Mac Eight Co., Ltd.

Product change notice / New size and material for tape-and-reel

This announcement affects tape-and-reel package.

Photo 1. 178 $\phi$  type (Left : Original Right : New)

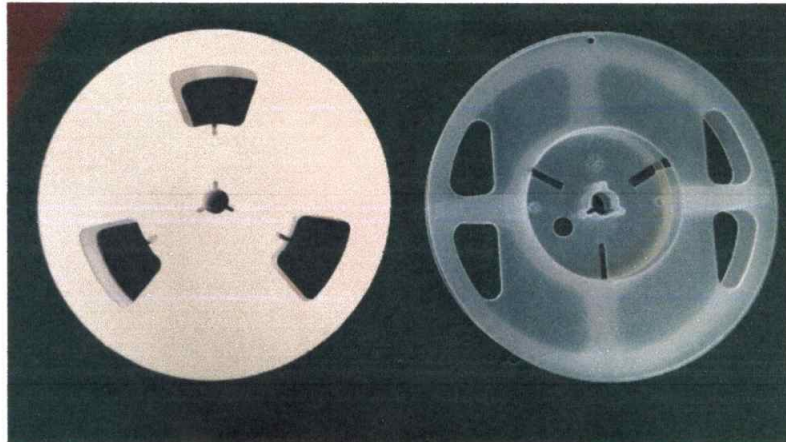
①Dimension of the reel

Original	New
1 $178\phi \times 80\phi \times 17.5$ (width:16mm)	$180\phi \times 60\phi \times 17.5$ (width:16mm)
2 $380\phi \times 80\phi \times 17.5$ (width:16mm)	No change
3 $380\phi \times 80\phi \times 25.5$ (width:24mm)	No change

About above 1, there is no influence for customer when setting up to the SMT machine.

②Material

Original	New
Paper	Plastic
